# HISTORIC AND DESIGN REVIEW COMMISSION

**HDRC CASE NO:** 2021-600  
**ADDRESS:** 602 AVENUE A  
**LEGAL DESCRIPTION:** NCB 14164 BLK 2 LOT 2 0.114 AC (CAN PLANT EAST SUBD)  
**ZONING:** IDZ, H, RIO-2  
**CITY COUNCIL DIST.:** 1  
**LANDMARK:** Individual Landmark  
**APPLICANT:** Jayme Gritch/Lake Flato Architects  
**OWNER:** RIO PERLA PROPERTIES LP  
**TYPE OF WORK:** Installation of attached patio awning  
**APPLICATION RECEIVED:** November 12, 2021  
**60-DAY REVIEW:** Not applicable due to City Council Emergency Orders  
**CASE MANAGER:** Edward Hall  
**REQUEST:**

602 Avenue A - Outdoor Dining Patio - Covered  
Supporting Documentation for Certificate of Appropriateness Request  
11.11.2021  
Lake|Flato Architects, Contact Jayme Gritch at jgritch@lakeflato.com;  
Vicki Yuan at vyuan@lakeflato.com

Proposed New Outdoor Dining - Roof Plan

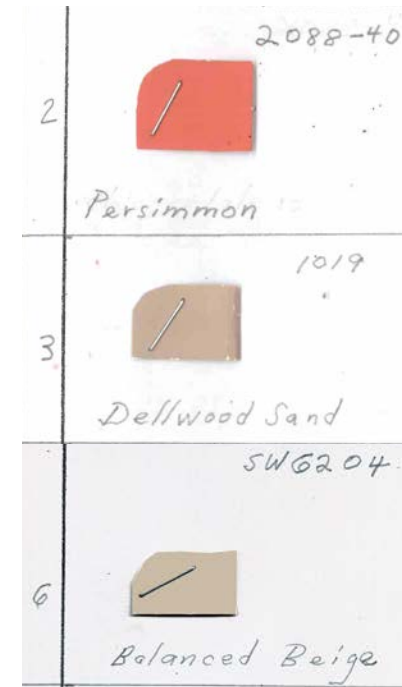
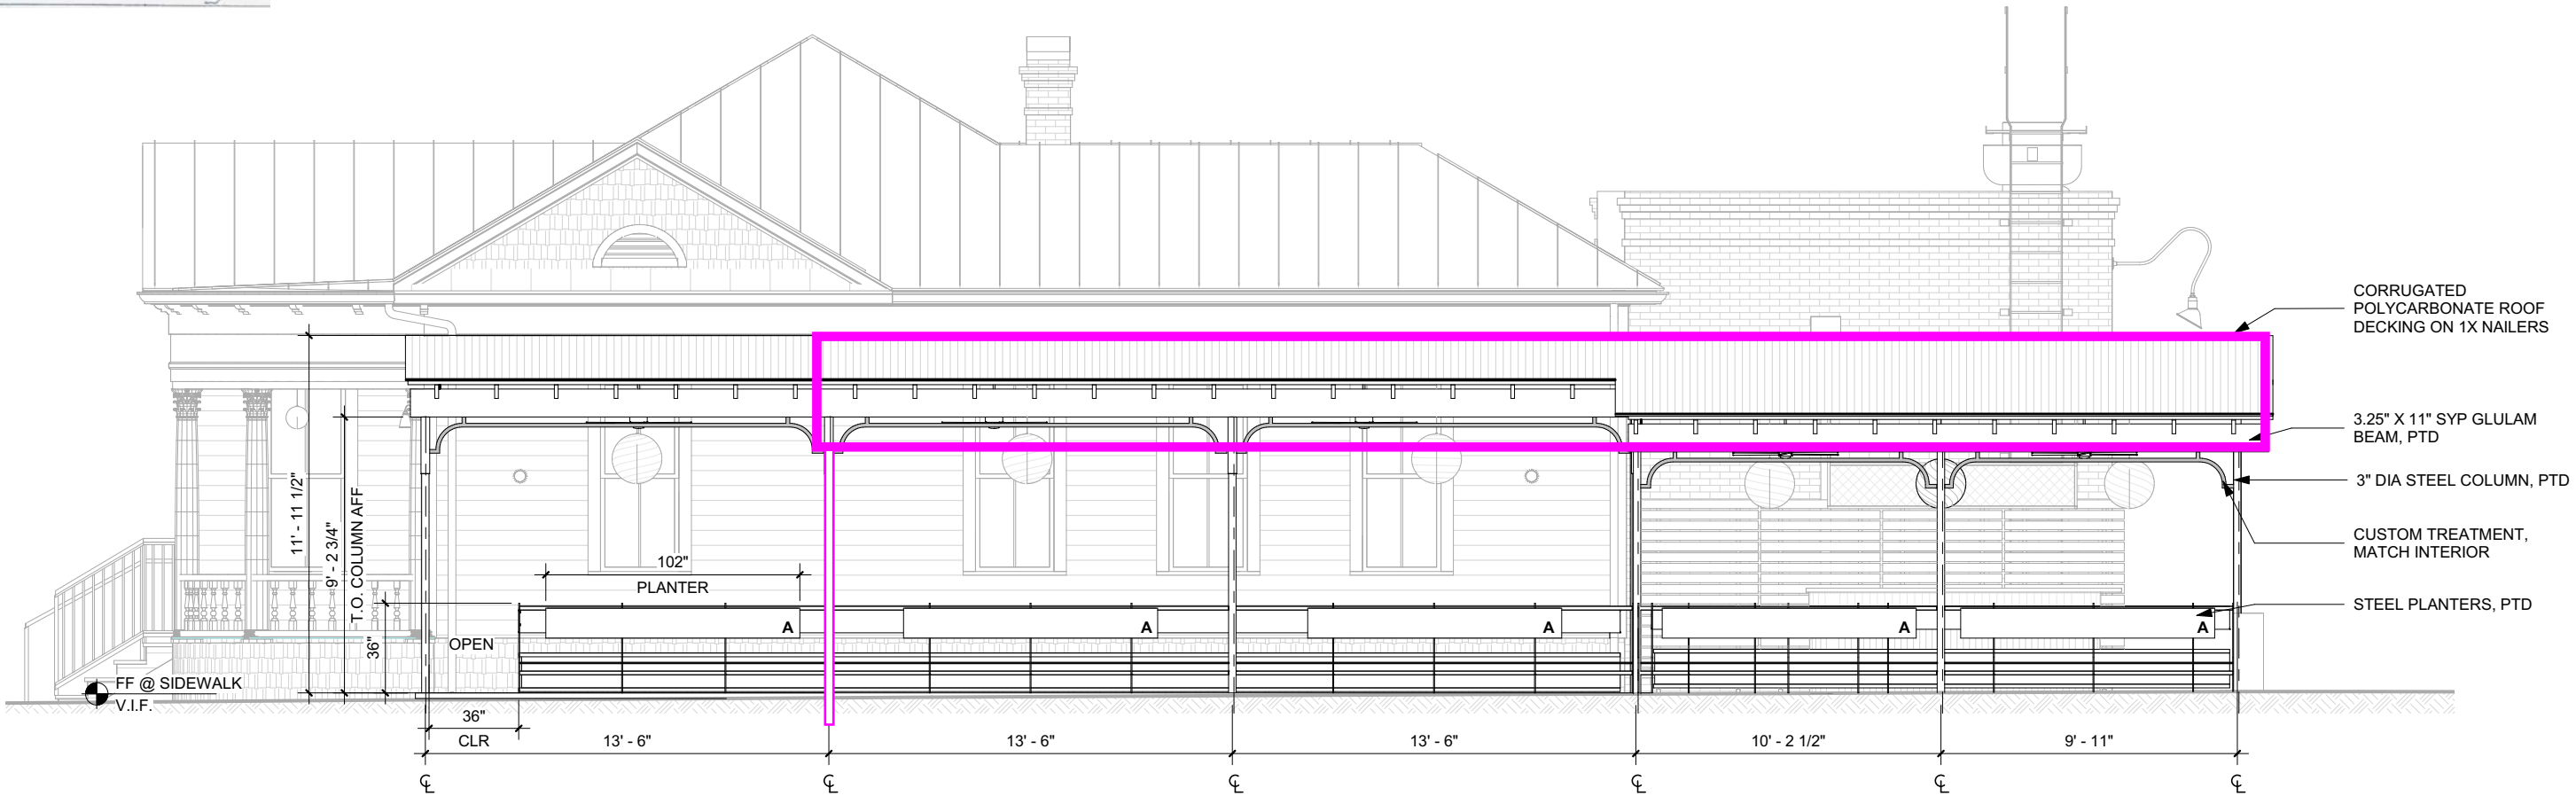
- d. PATIO COVER (Materials) – The applicant has proposed materials that include a wood and steel patio canopy structure and a corrugated polycarbonate roof. The Guidelines for Additions 3.A.i. notes that materials that match in type, color, and texture and include an offset or reveal to distinguish the addition from the historic structure should be used whenever possible. Any new materials introduced to the site as a result of an addition must be compatible with the architectural style and materials of the original structure. Additionally, the Guidelines for Additions 3.A.iii. notes that original roofs should be matched in terms of form and materials. Generally, staff finds the proposed patio cover to be consistent with the Guidelines; however, staff finds that the patio cover should feature a roofing material that is consistent with the historic structure's standing seam metal roof. Plastic building materials are not appropriate for historic structures.

- 1. Staff recommends approval of item #1, the construction of a patio cover addition, based on findings a through e with the following stipulations:
  - i. That the proposed patio cover be set back behind the side gable.
  - ii. That the proposed patio cover feature a standing seam metal roof with panels that are 18 to 21 inches wide, seams that are 1 to 2 inches in height, and a standard galvalume finish.
- 2. Staff recommends approval of item #2, an outdoor bar and patio seating as submitted based on finding f.
- 3. Staff recommends approval of item #3, utility panels and screening as submitted based on finding g.
